To: Ken Roberts, City of Lake Elmo Planning Director
From: Lucius Jonett, Wenck Landscape Architect
Date: October 2, 2019
Subject: City of Lake Elmo Landscape Plan Review
Lake Elmo Independent Living Review #1

Submittals

- Site Demolition (Tree Preservation) Plan, dated September 12, 2019, received September 25, 2019.
- Landscape Plans, dated September 12, 2019, received September 25, 2019.

L101

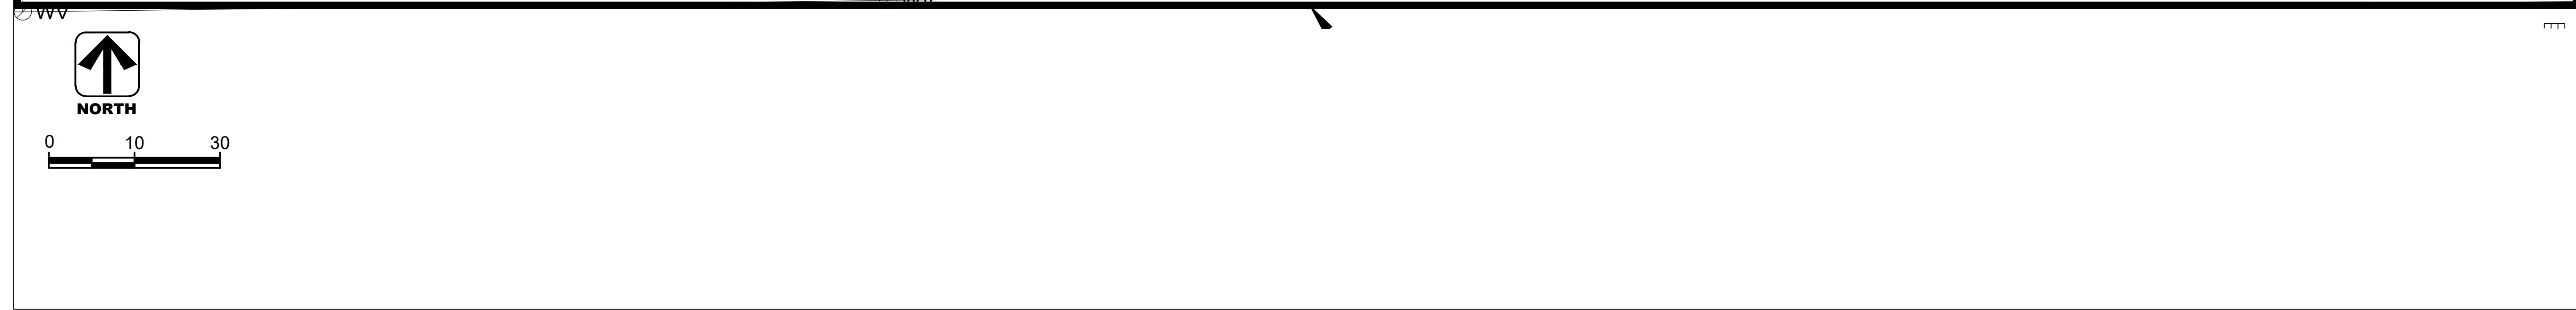
- A. A landscape plan has been submitted that **does not include** all requirements.
1. All utilities and pavements **are not** shown on the landscape plan to review for tree placement conflicts.

- B. The landscape plan **does not include** the landscape layout requirements:
- *No utility conflicts with proposed tree locations; Prefer that the trunk of trees shall be 10 feet from the nearest utility, including water and sewer service stubs to each lot. Current ordinance is 5 feet minimum from nearest utility.*

- All utilities and pavements are not shown on the landscape plan to review for tree placement conflicts. We marked 8 trees on the attached figure that have potential of having a utility conflict.

1. Submit a revised landscape plan including the following:
 - a. Plans signed by a licensed landscape architect.
 - b. Utility lines shown to ensure that trees are not planted on top of or too close (within 10') to proposed utilities.
 - c. Provide additional detail on any decorative materials, access control or lighting used for Pedestrian Improvements.
 - d. Provide a plan or additional detail on the resource efficient irrigation system used for Enhanced Landscaping.
 - e. Provide a plan or additional detail on the theming elements (signage, fencing, landscaping, lighting and site furnishings) used for Theming amenity points.
